Niagara Mohawk Power Corporation

License No. DPR-63

Docket No. 50-220

Proposed Changes to Technical Specifications (Appendix A)

Figure 3.1.7a MAXIMUM ALLOWABLE AVERAGE PLANAR LHGR APPLICABLE TO 8DB250 FUEL AS DESCRIBED IN REFERENCE 8.

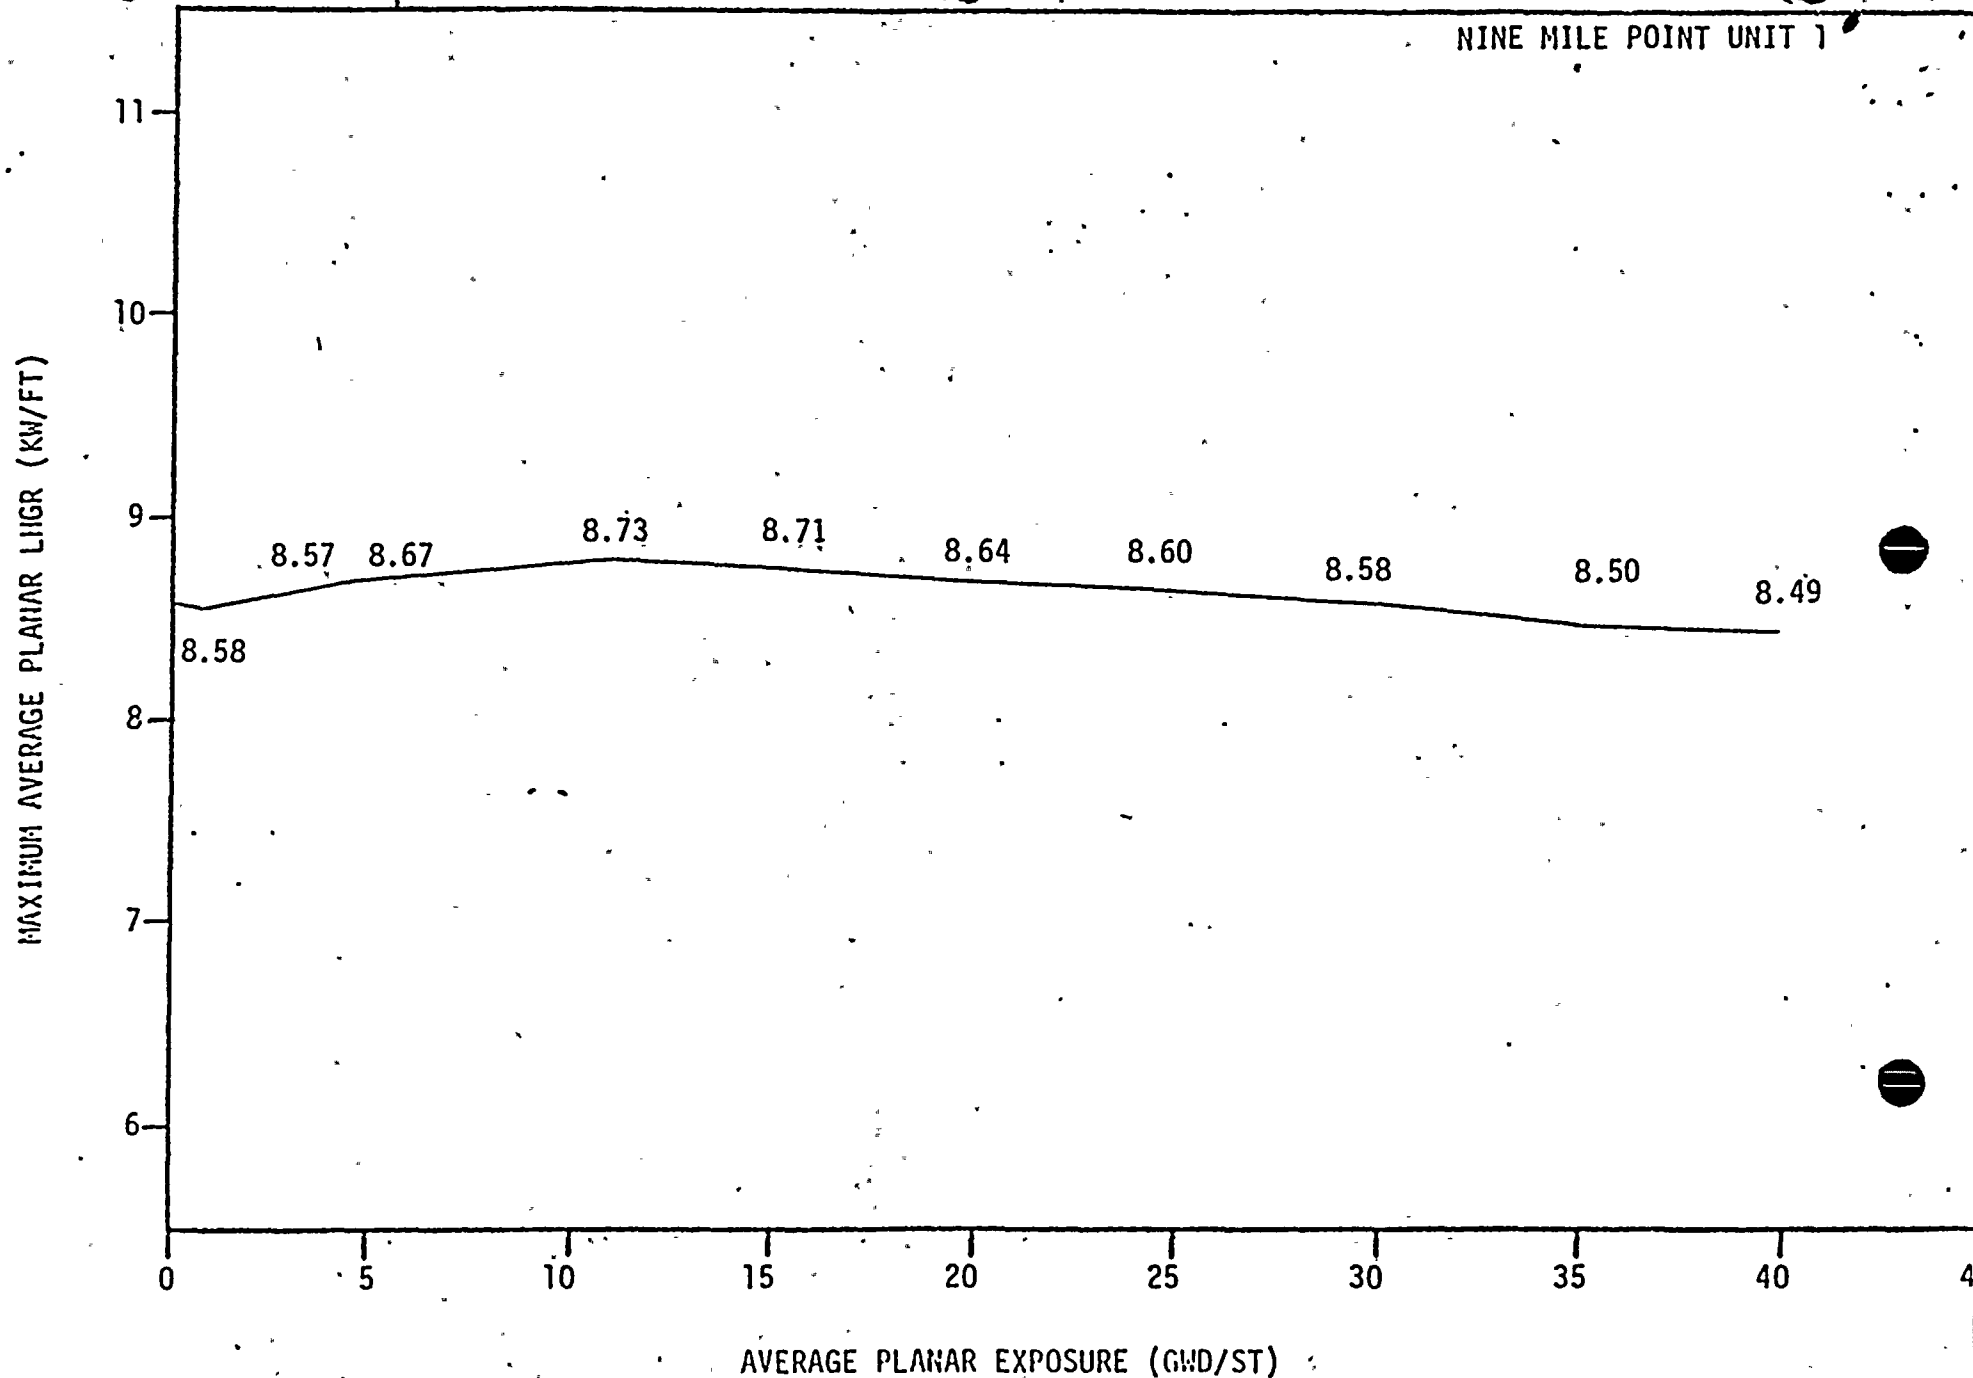
MAPLHGR limit curves for 8DB250, 8DB274L and 8DB274H fuel types are revised to remove fission gas MAPLHGR reduction factors at high exposures. These penalties are deleted based on References 3 and 4. In these General Electric has demonstrated sufficient peak clad temperature (PCT) margin due to approved ECCS model improvements not taken credit for. These improvements compensate for PCT increase due to enhanced fission gas release at high exposures. That evaluation addressed the NRC fission gas release concerns and provided justification for elimination of any penalties for MAPLHGR limits calculated with current models.

AVERAGE PLANAR EXPOSURE (GWD/ST)  
Figure 3.1.7c Maximum Allowable Average Planar LHGR Applicable to 8DNB277  
Fuel as described in Reference 8.

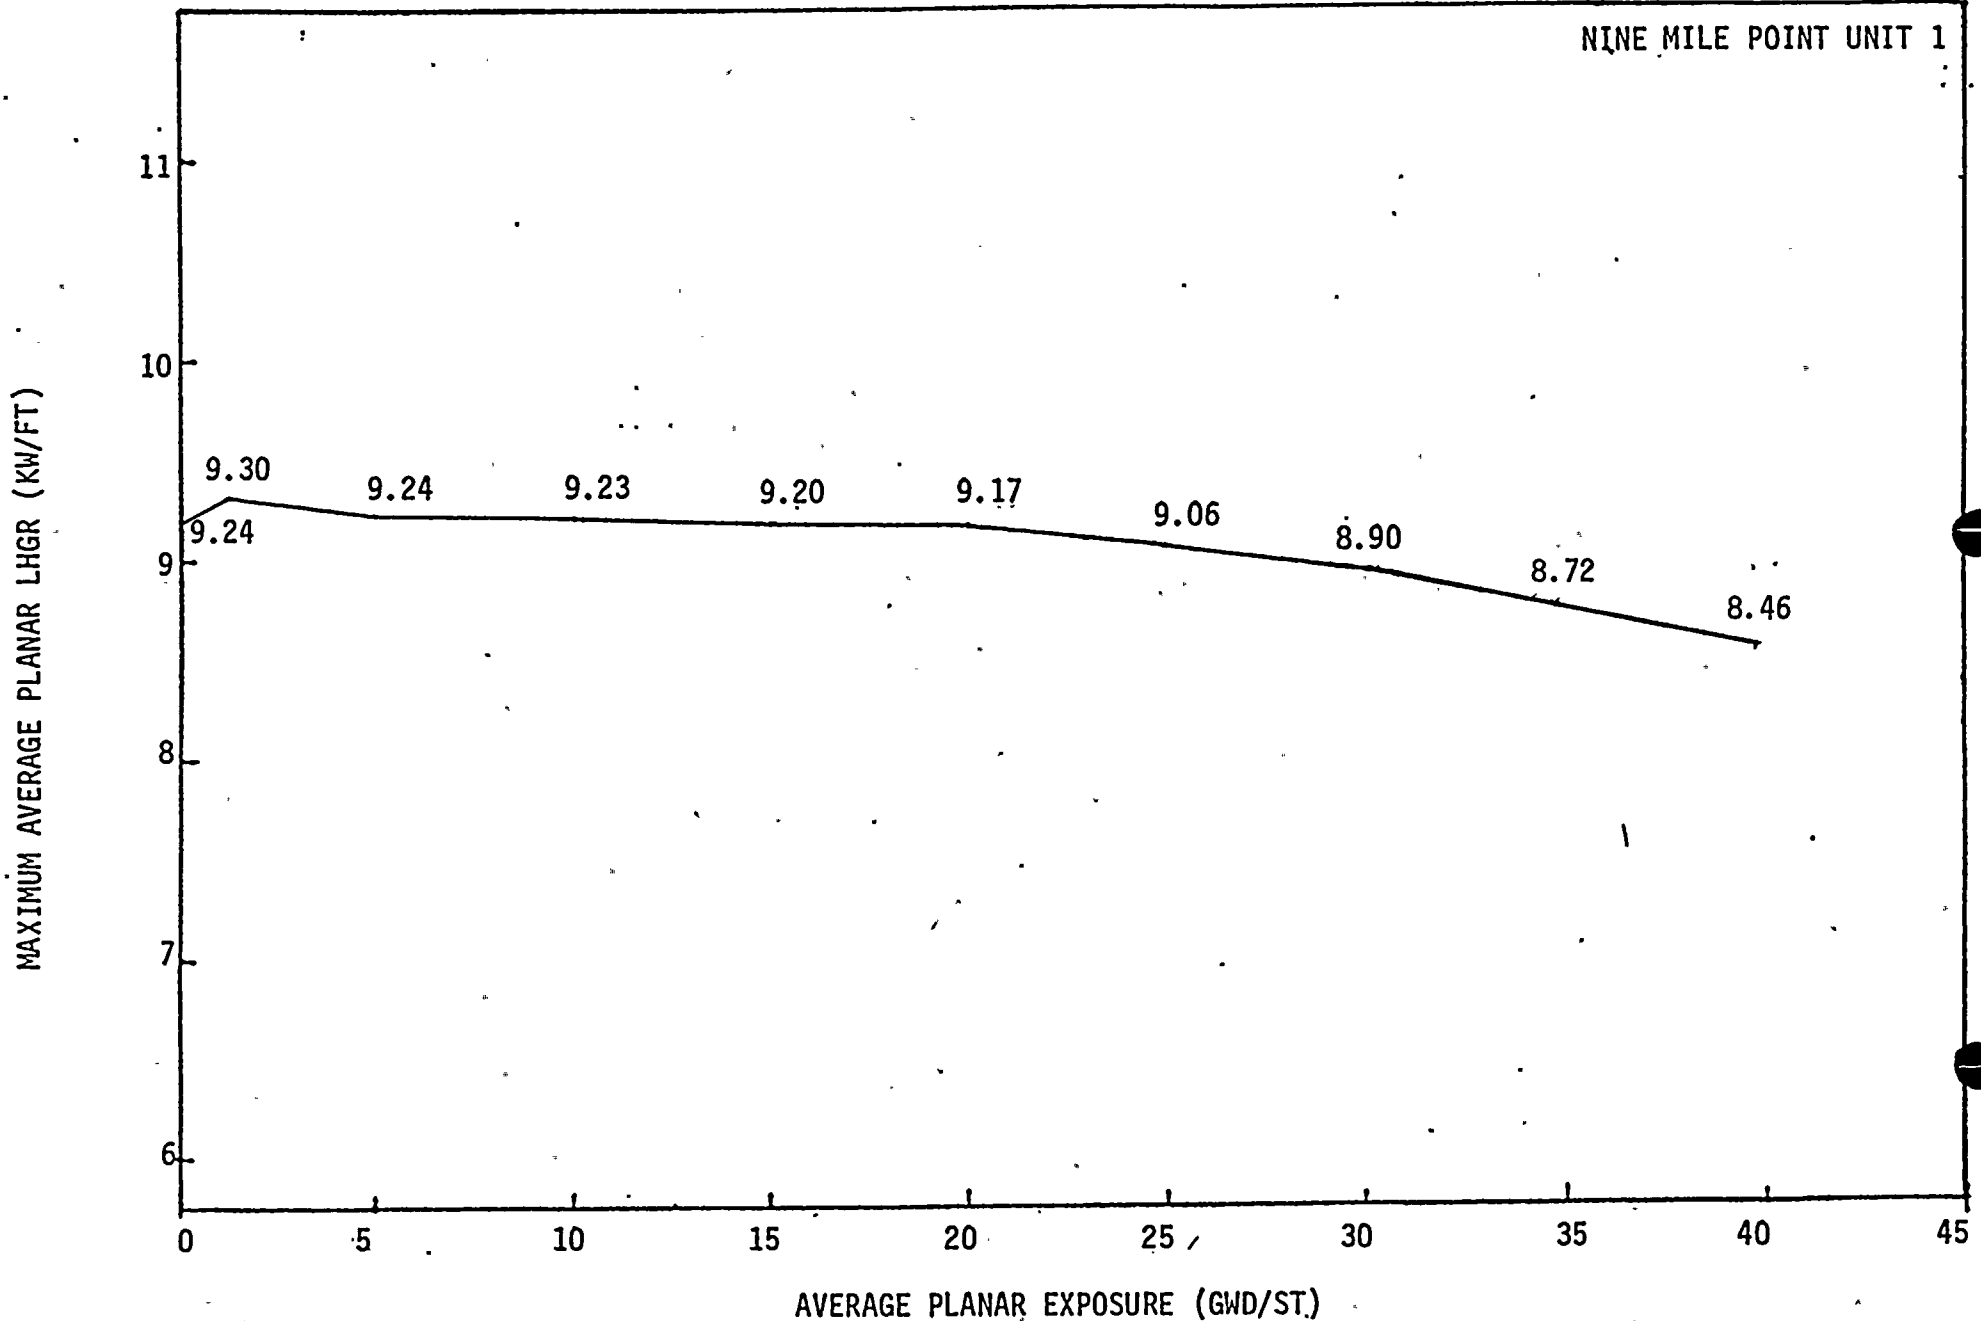
The LOCA performance of fuel types 8DNB277 and P8DNB277 was reanalyzed per the enclosed report. As a result, these fuel types required reevaluation of the PCT margins available to compensate for enhanced fission gas release effects. This reevaluation indicated the need to apply fission gas MAPLHGR reduction factors to the limits developed in the attached reanalysis. Reduction factors were found to be needed at 35 and 40 GWD/ST exposures. The same method as was used in References 3 and 4 was used to develop these reduction factors which are included in the revised MAPLHGR limit curves for these two fuel types.
